City of Albuquerque

RE: DRAINAGE PLAN FOR A FOUR-PLEX APARTMENT BUILDING
(K-16/D36) REVISION DATED MAY 12, 1989

GRADING AND DRAINAGE PLAN
FOUR-PLEX APARTMENT BUILDING
211 PRINCETON DRIVE, S.E.
ALBUQUERQUE, NEW MEXICO

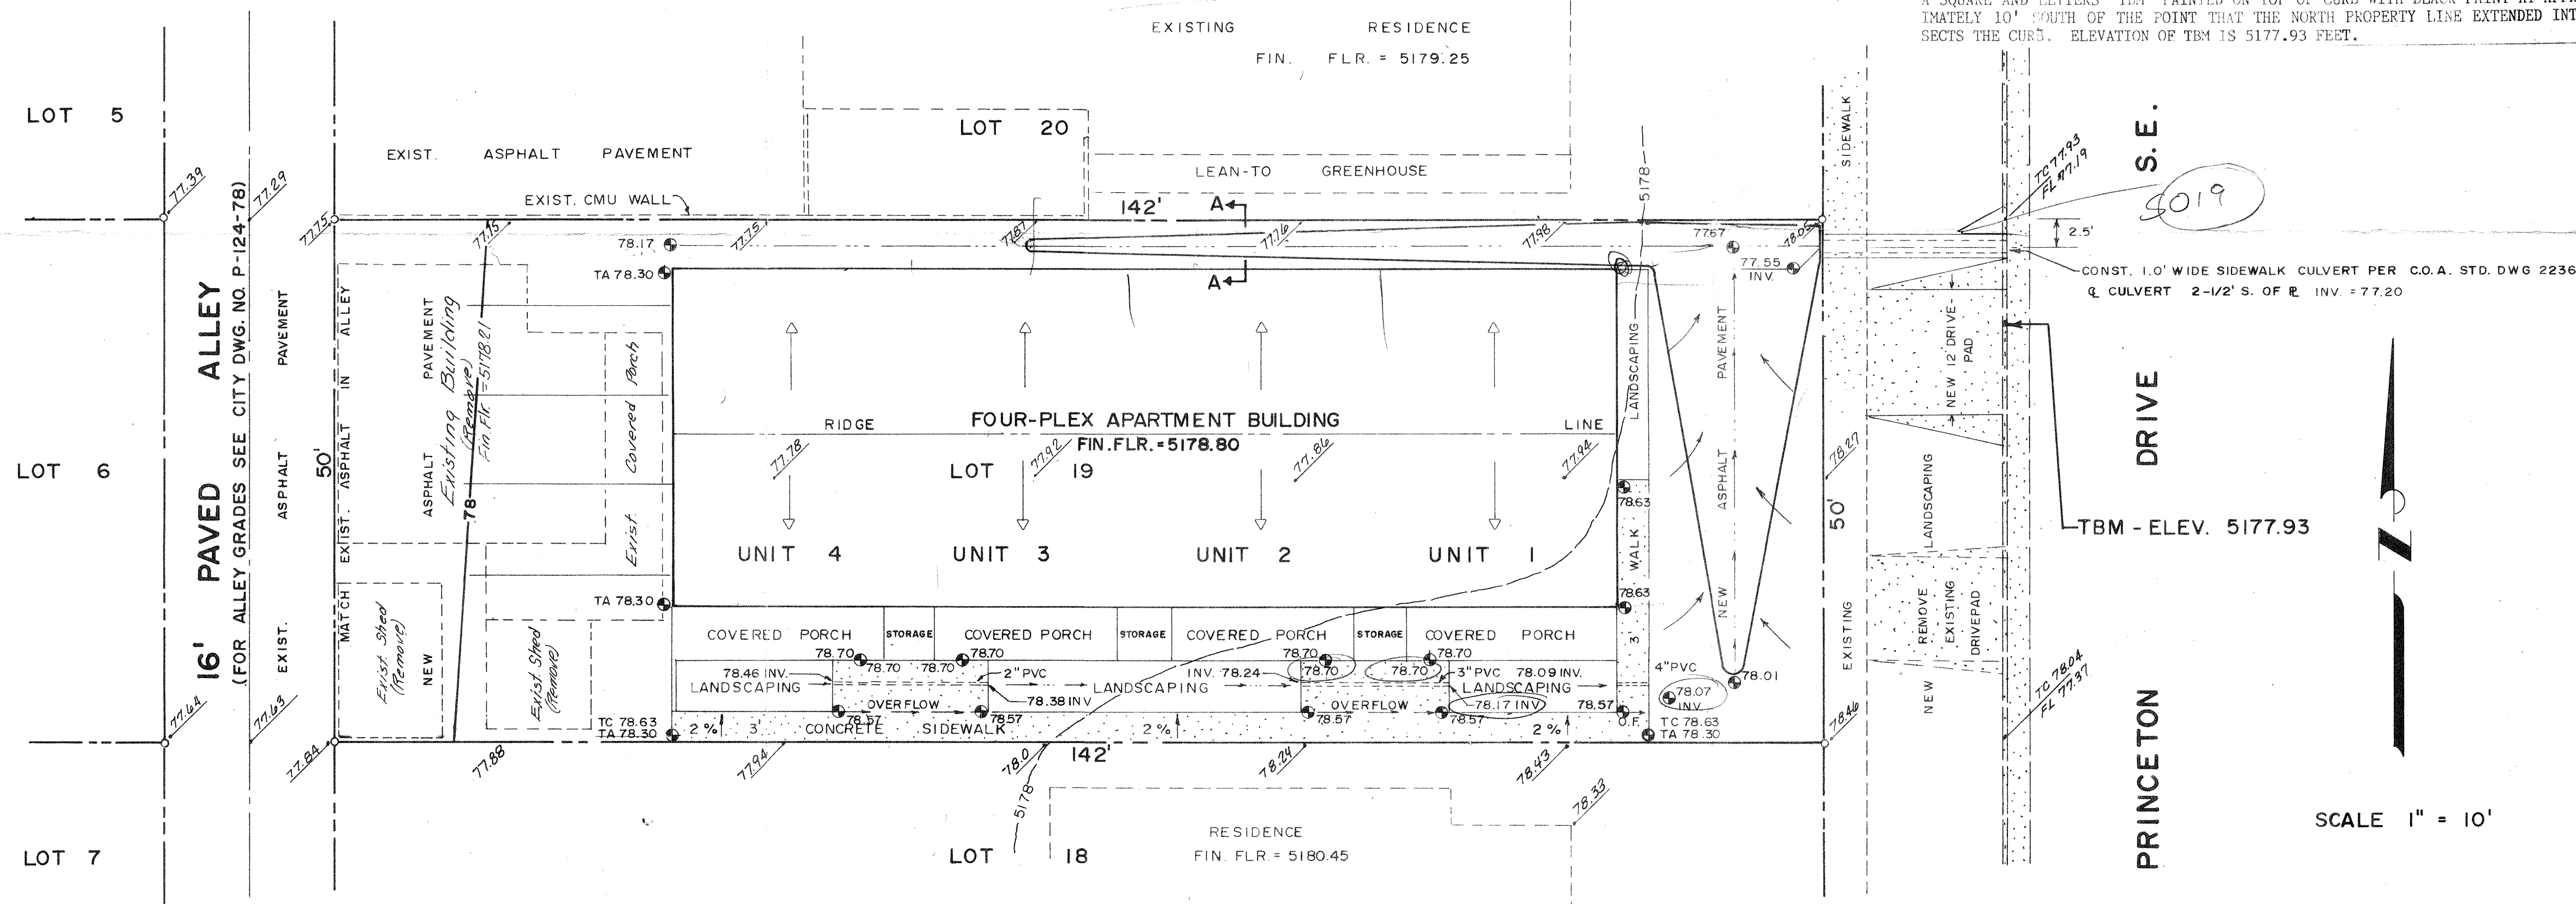
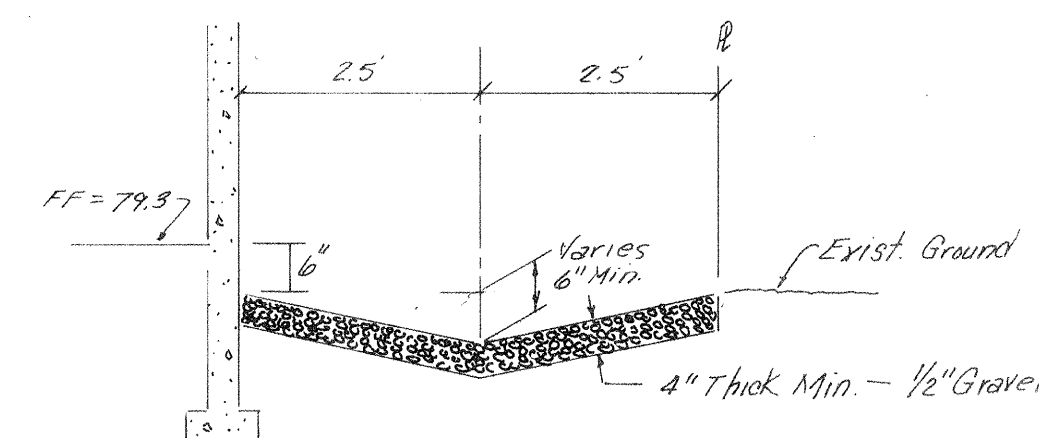
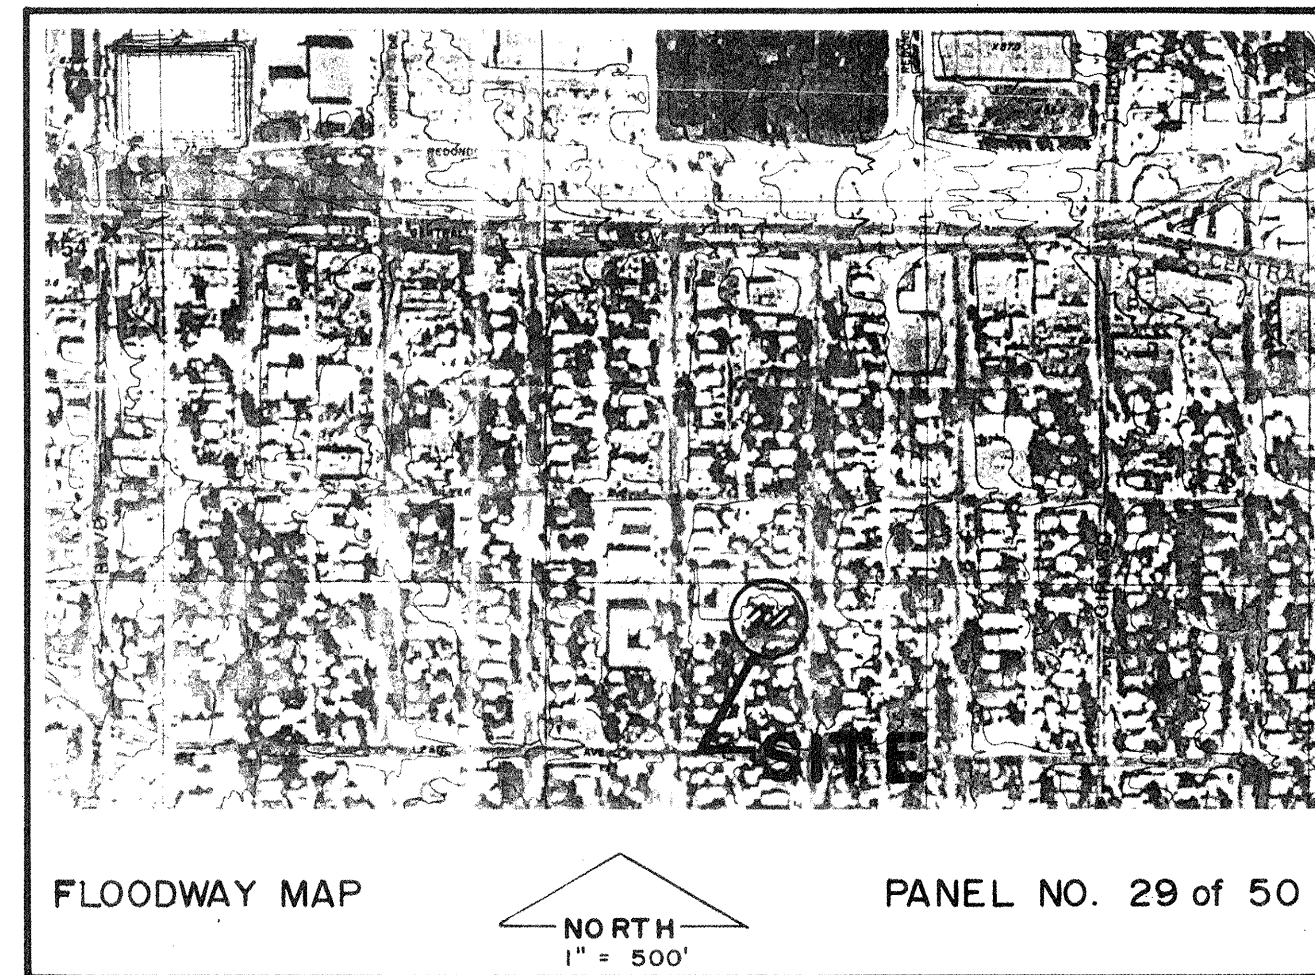
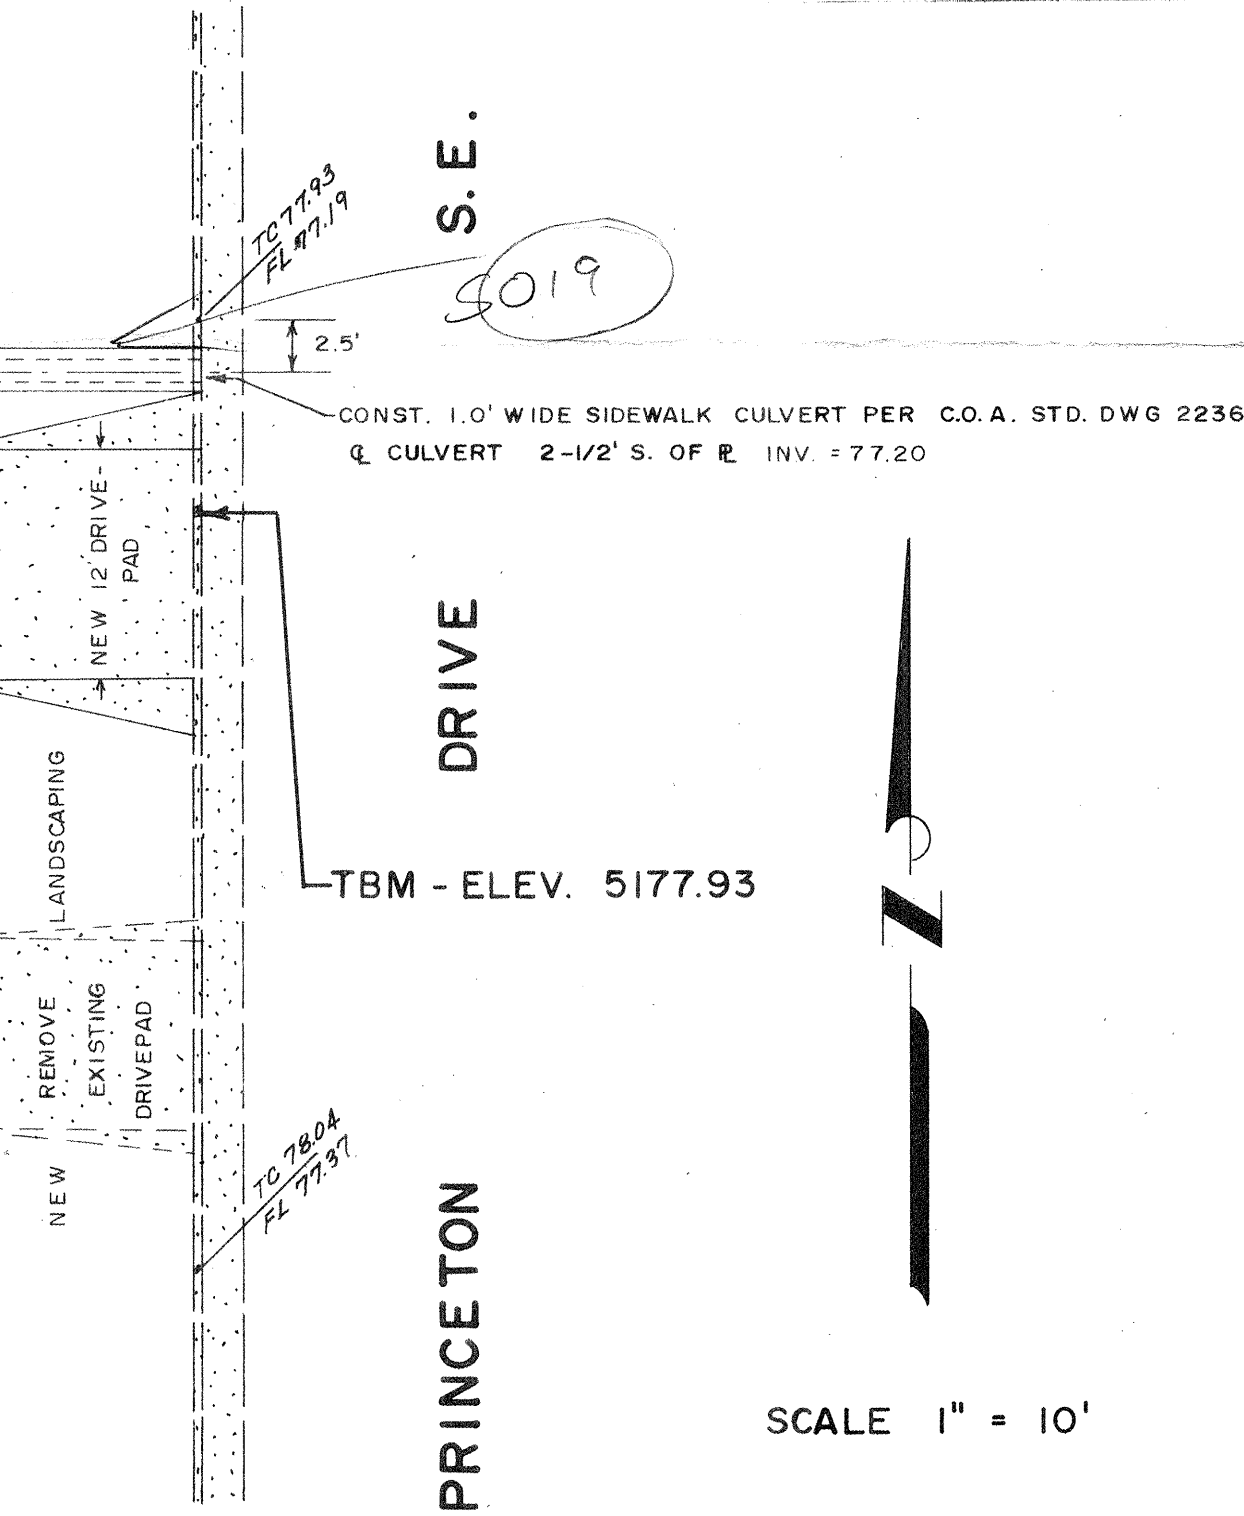
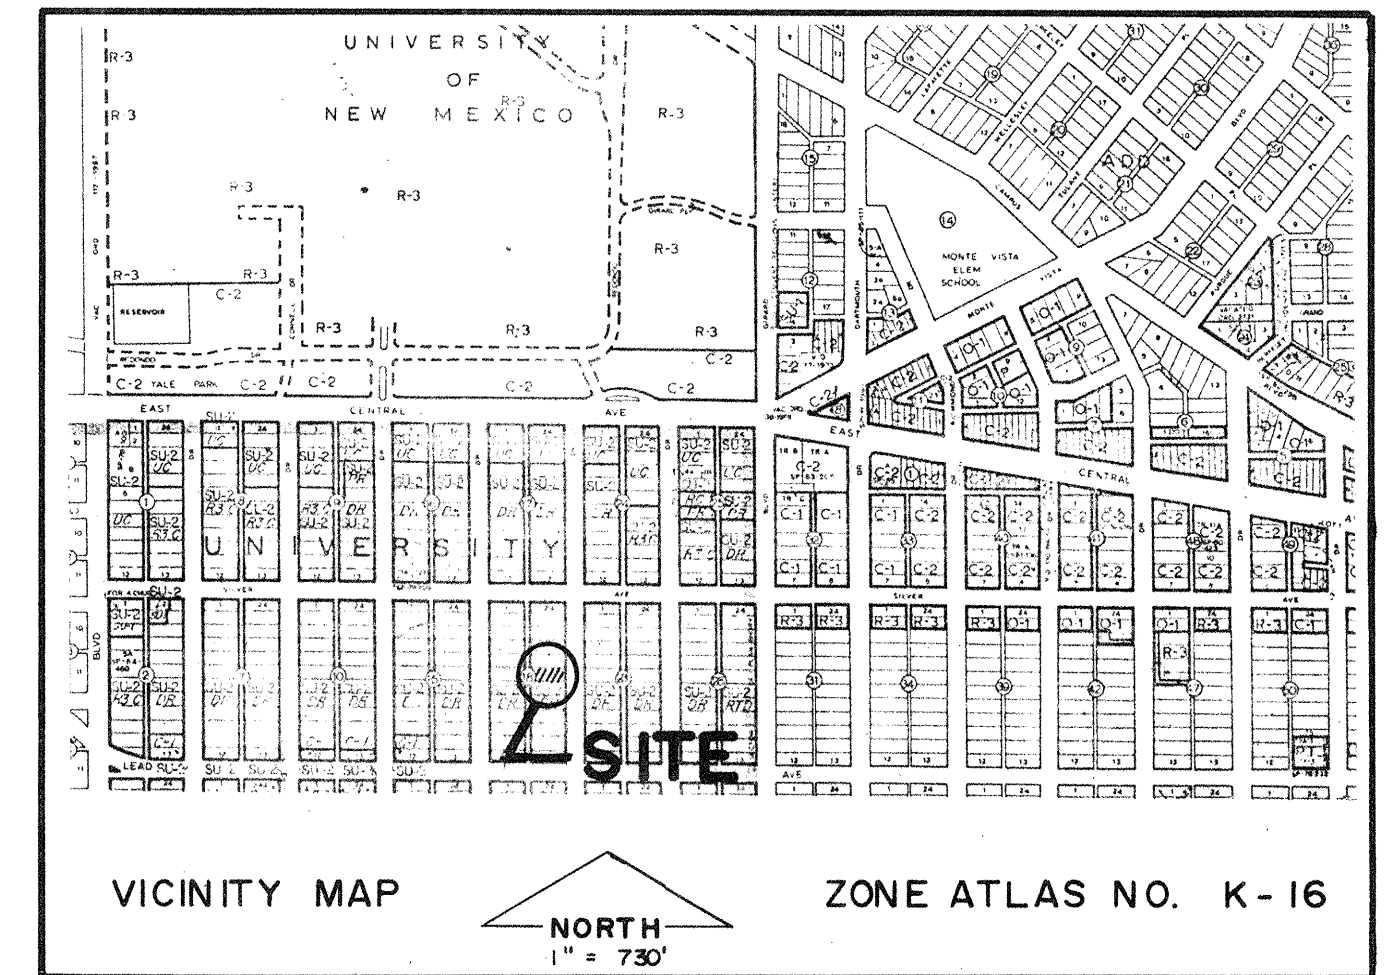
1. DRAINAGE PLAN PER D.P.M. GUIDELINES REQUIRED PRIOR TO BUILDING PERMIT RELEASE.
2. FREE DISCHARGE TO PRINCETON IS ACCEPTABLE.
3. FREE DISCHARGE TO ALLEY IS ACCEPTABLE IF ALLEY IS PAVED AND HAS CAPACITY ALL THE WAY TO MAIN STREETS. PROVIDE VERIFICATION WITH DRAINAGE SUBMITTAL.
4. APPROVED ALLEY GRADES ARE REQUIRED TO COMPARE WITH SITE GRADES.
5. ALLEY FLOWS ARE FROM SOUTH TO NORTH.
6. IDENTIFY ANY OFF-SITE FLOWS ENTERING THE SITE.

1. THE D.P.M. GUIDELINES WERE USED IN PREPARATION OF THIS GRADING AND DRAINAGE PLAN.
2. THE SITE HAS BEEN GRADED TO DRAIN MOSTLY TO PRINCETON DRIVE TO MINIMIZE DISCHARGE TO THE ALLEY.
3. THE AMOUNT OF FLOW DISCHARGING TO THE ALLEY WILL BE REDUCED AFTER DEVELOPMENT. THE ALLEY IS PRESENTLY PAVED.
4. APPROVED ALLEY GRADES ARE PER CITY PROJECT P-124-78. ONLY CENTERLINE GRADES ARE SHOWN ON THE PLAN AND PROFILE AND THERE IS NO TYPICAL SECTION.
5. FIELD ELEVATIONS CONFIRM THAT ALLEY FLOWS ARE FROM SOUTH TO NORTH.
6. THERE ARE NO OFF-SITE FLOWS ENTERING THE SITE. ALL LOTS DRAIN EITHER TO PRINCETON OR THE ALLEY. THERE IS NO SIGNIFICANT CROSS-LOT-LINE DRAINAGE.
